**U.S. ENVIRONMENTAL PROTECTION AGENCY, REGION 8
UNDERGROUND INJECTION CONTROL PROGRAM
STATEMENT OF BASIS**

PERMITTEE:	Hilcorp Energy Company
FACILITY NAME AND API:	Argenta Ute #2 SWD API 05-067-06164
PERMIT NUMBER:	CO20845-04426
RESPONSIBLE OFFICIAL:	Mitch Killough mkillough@hilcorp.com 713-757-5247 (Office) 281-851-2338 (Mobile)
FACILITY CONTACT ADDRESS:	Hilcorp Energy Company 1111 Travis St. Houston, Texas 77002
PERMIT TYPE:	Class II, Individual Permit
FACILITY LOCATION:	Argenta Ute #2 SWD NW/SE Section 31, T34N, R10W Lat/Long: 37.144631, -107.971179 Ignacio Blanco Field La Plata County, Colorado

Figure 1 Hilcorp identified wells and Surface water diversions Argenta Ute #2 SWD

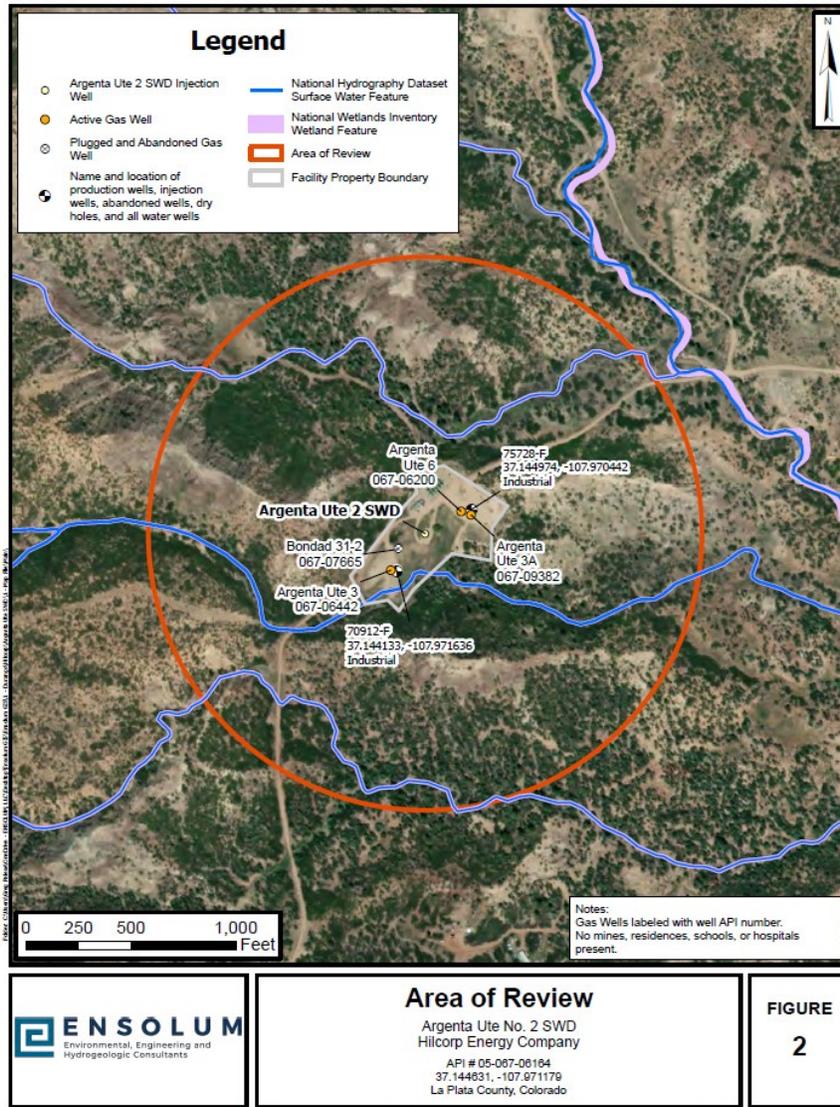
EPA evaluated the AoR consistent with 40 C.F.R. § 146.24(a) and determined that a fixed-radius AoR of ¼ mile is appropriate and protective of underground sources of drinking water (USDWs). As shown on the AoR map (Figure 1), six wells fall within the ¼-mile boundary. Review of well records indicates these wells do not provide a pathway for fluid migration out of the injection zone into a USDW because: they do not penetrate the confining zone that isolates the injection interval; they have been properly plugged and abandoned with cement; they are not drilled into the Mesaverde Formation associated with the project, and they lack any conduit (e.g., open annuli or compromised casing/cement) that could transmit fluids.

Given these conditions, the wells within the AoR do not compromise confining unit integrity or create hydraulic communication with USDWs. Therefore, a ¼-mile fixed-radius AoR is sufficient to identify and address potential migration pathways and is protective under 40 C.F.R. § 146.24(a). The AoR map (Figure 1) identifies 6 wells within the ¼ mile AoR boundary.

Figure 2 Earthquake data from USGS in relationship to Argenta Ute #2 well.

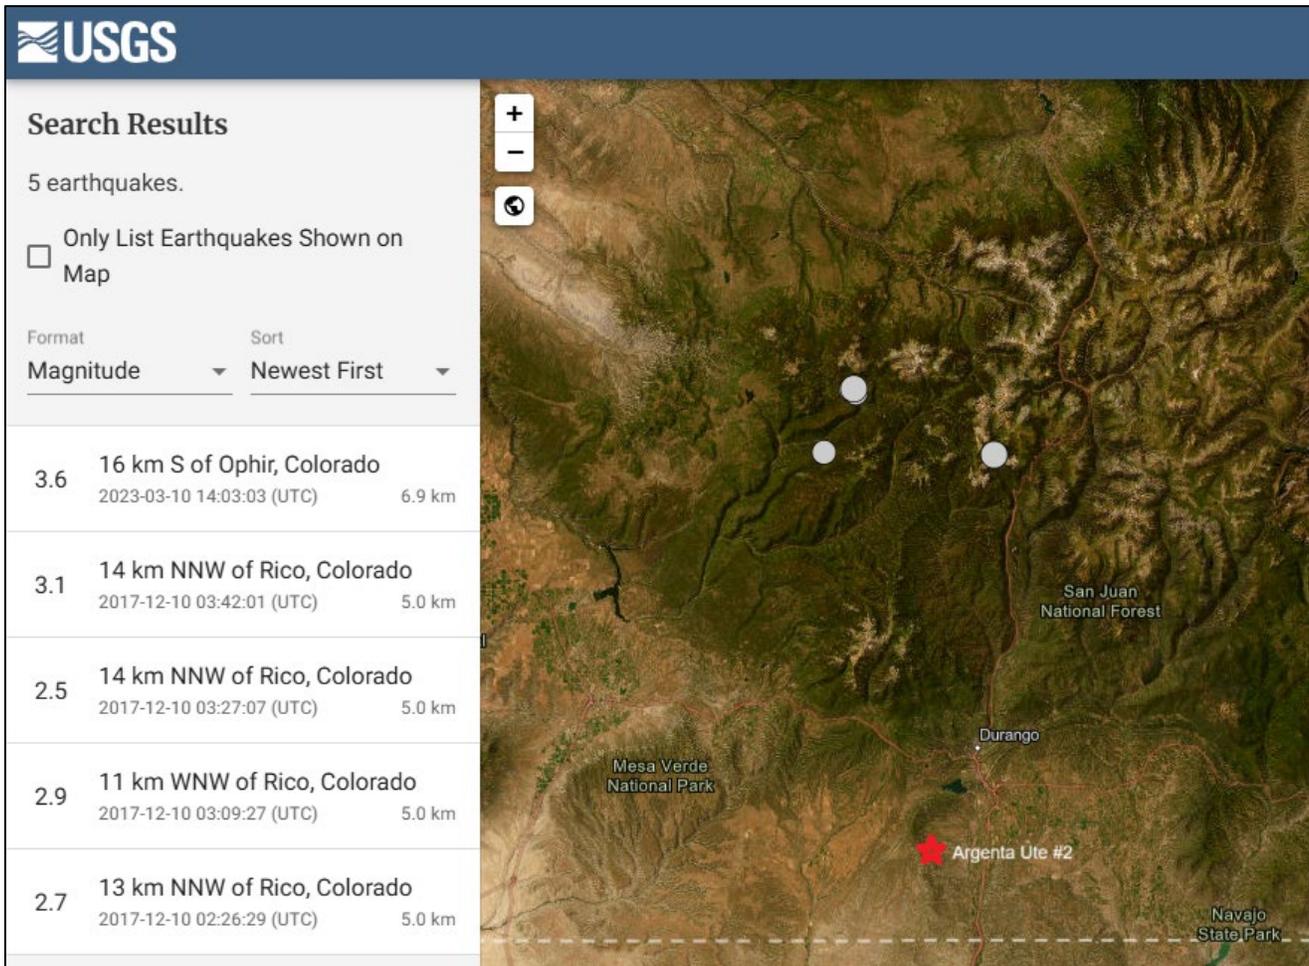
In addition to review of the formations and wells within the ¼ mile fixed radius, EPA reviewed U.S. Geologic Service (USGS) data (Figure 2) to determine if any faults are within the AoR, or if any earthquakes have occurred near the wells.

No faults exist in or near the ¼ mile fixed AoR for the Argenta Ute #2 well. The nearest faults, designated as the Class B Unnamed Faults Near San Miguel Canyon, are located approximately 60 miles north of the well location.
